BOARD ACTION REPORT – APPEALABLE ITEM

Project Name: AutoNation Land Rover Jaguar of Delray Beach

SITE PLAN REVIEW AND APPEARANCE BOARD STAFF REPORT

File No.: 2019-120-SPF-SPR-CLIV

SHEET TITLE: LANDSCAPE PLAN SHEET NUMBER: L-4

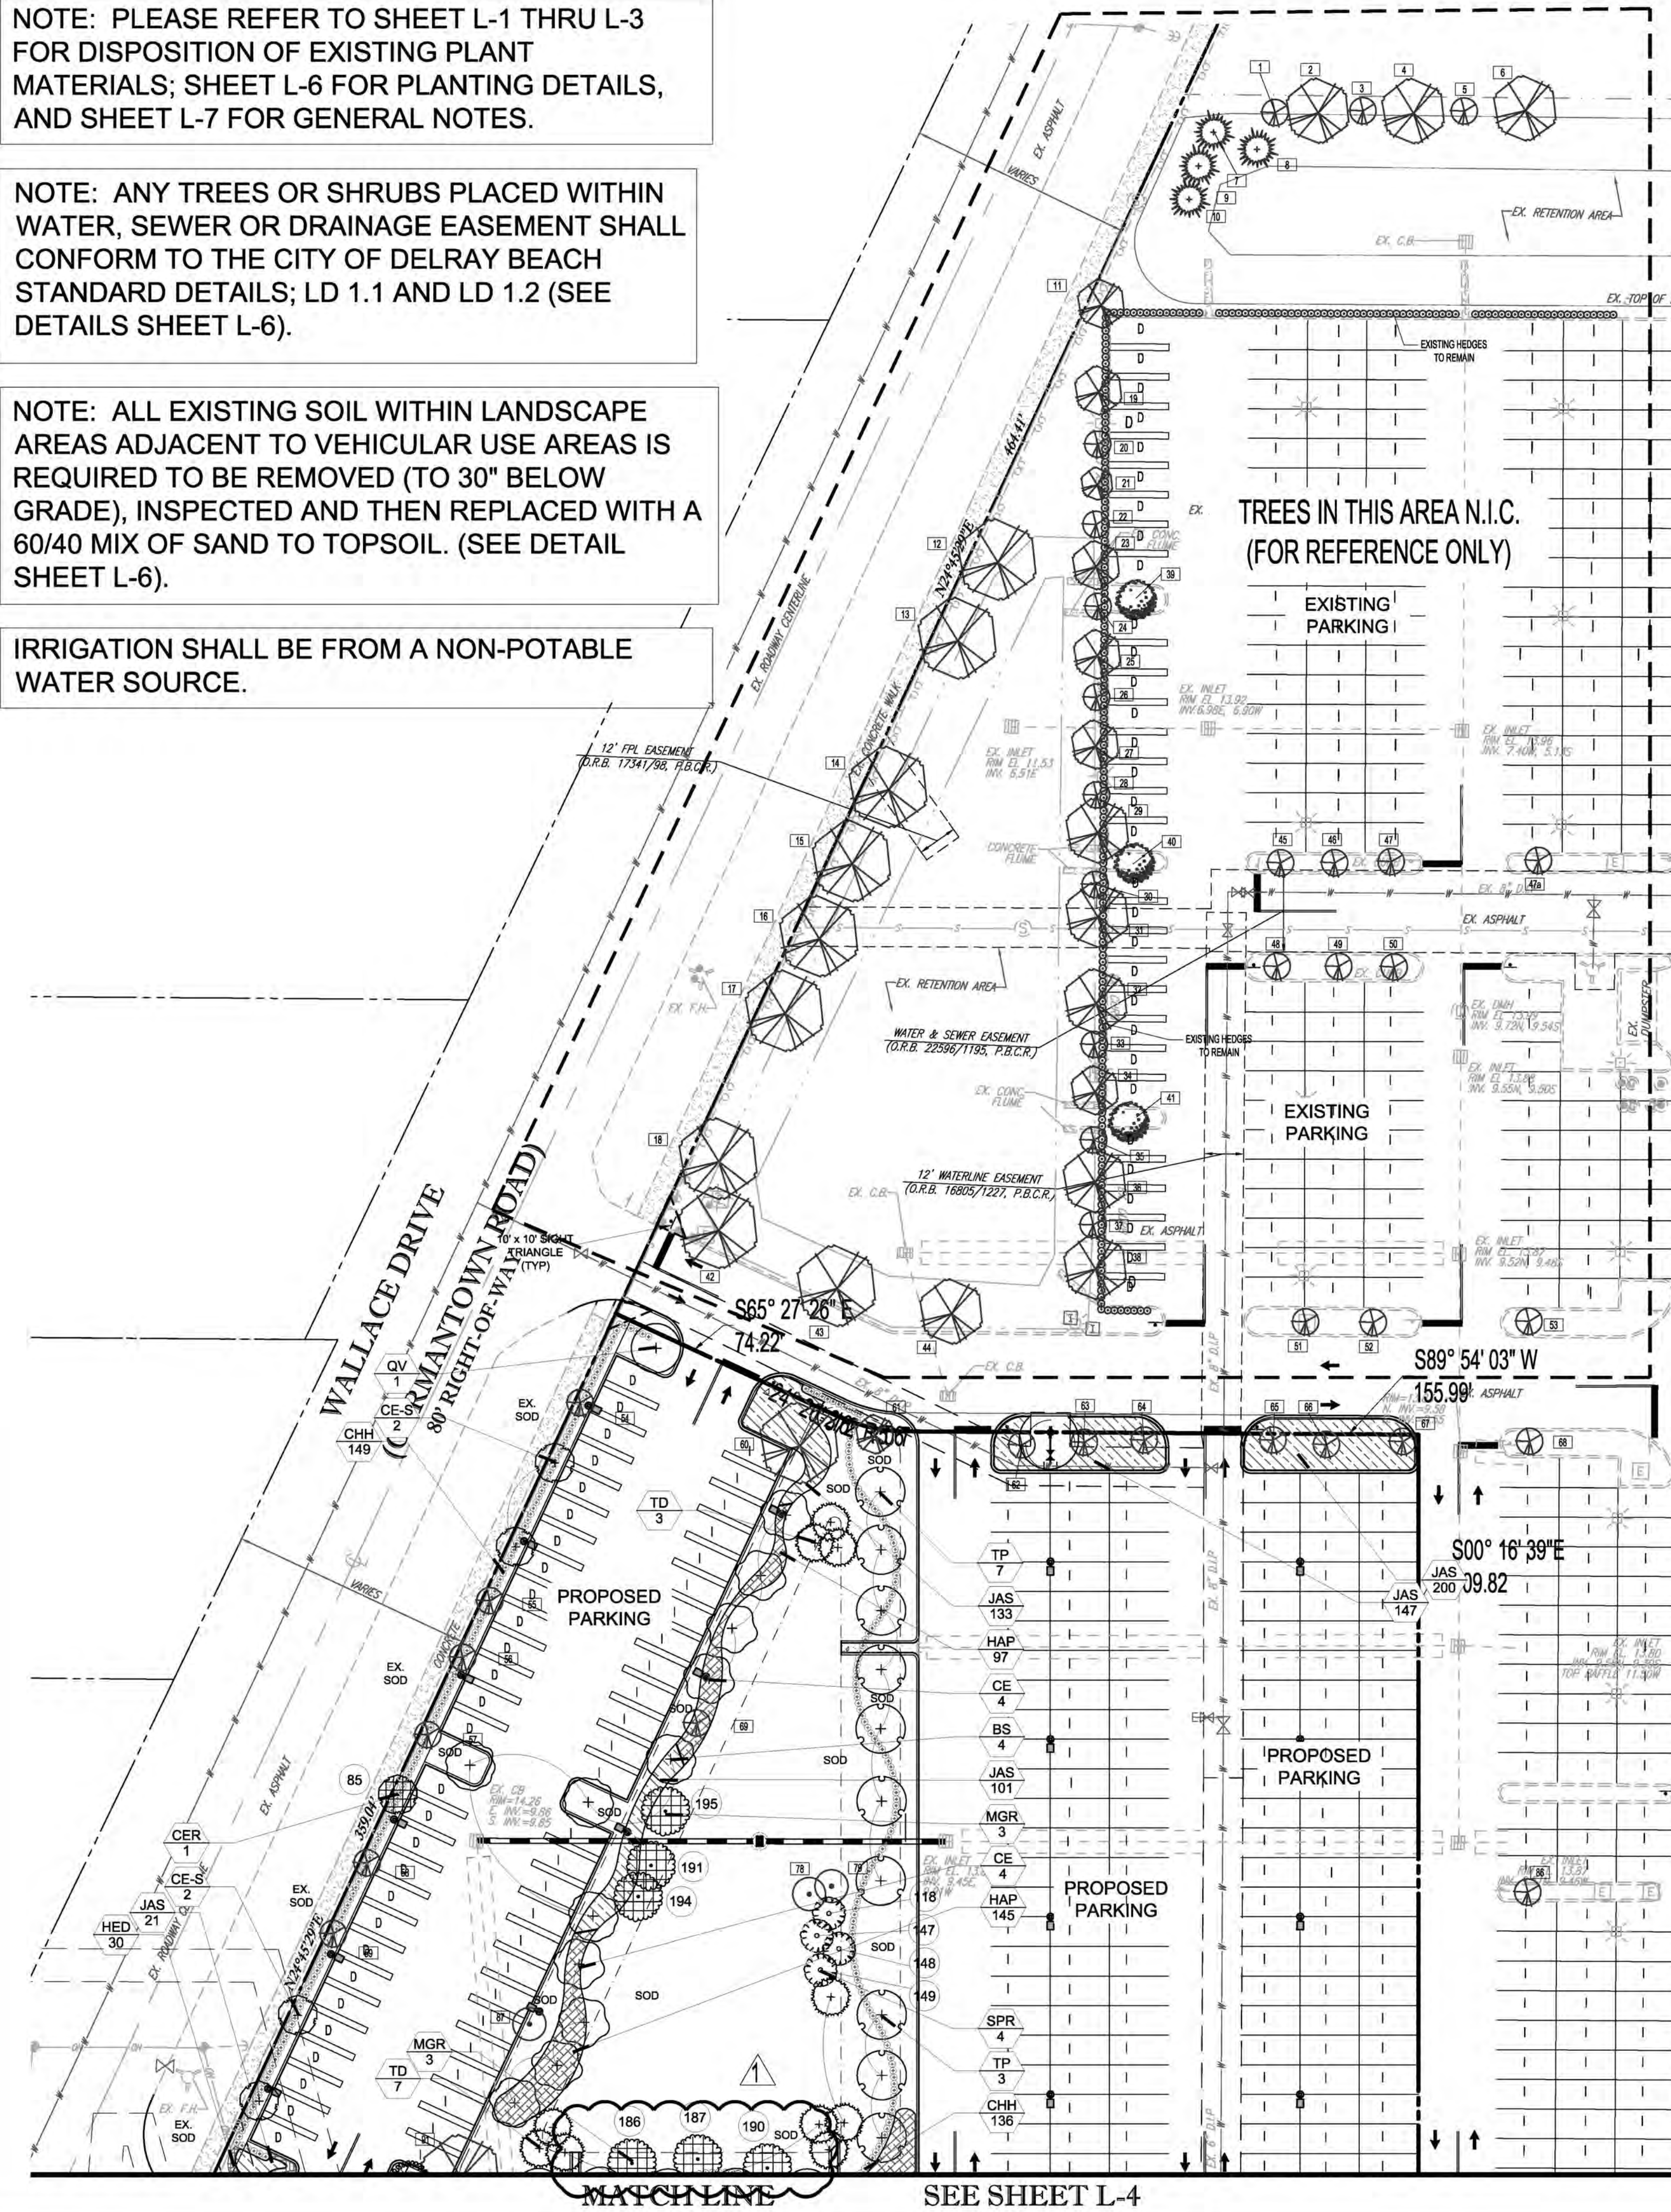
At its meeting of September 25, 2019, the Site Plan Review and Appearance Board (SPRAB) considered and postponed action on the Class IV Site Plan Modification for **AutoNation Land Rover Jaguar of Delray Beach** and provided the applicant direction on changes to be made. The Board had the following observations/concerns regarding the proposed landscape plan:

- Concerns regarding the height and the proposed location of existing trees to be relocated on site along Linton Blvd.
- Direction to redesign the landscape area along Linton Blvd. to include a more robust, attractive design was presented as the property location serves as a gateway to the City.
- Concerns with the shade tree spacing requirement per LDR Section 4.6.16(H)(3)(a), along the perimeter landscape facing Linton Blvd were expressed.
- Redesign the landscape plan to include additional foundation planting around the building was discussed.

The proposed Landscape Plan was redesigned as directed by the SPRAB. The revised landscape plan has been submitted and evaluated by the Senior Landscape Planner and found to be in compliance. The revised areas are identified on the plans (L-4 and L-5); the remaining areas were not modified. The following is a narrative of the proposed changes.

- The existing Magnolia trees proposed to be relocated on-site were moved from the southern property line perimeter to the interior landscape areas around the detention pond.

- The perimeter landscape buffer facing Linton Blvd. was redesigned to include seven 20 ft. greywood Royal Palms, planted 30 ft. on center/apart from each other. Three 18 ft. overall height Live Oak trees were added between the proposed Royal Palms along the perimeter landscape buffer facing Linton Blvd.

- The proposed landscape tiers along Linton Blvd. were redesigned to increase the number of shrubs, ground covers, and to introduce additional pockets of seasonal color.

- To soften the blank walls along the north elevation of the building, two additional trees (Crape Myrtle and Silver Buttonwood) were added to the foundation plantings in front building, and the proposed hedge (Podocarpus) was increased to 5 to 6 ft. high.
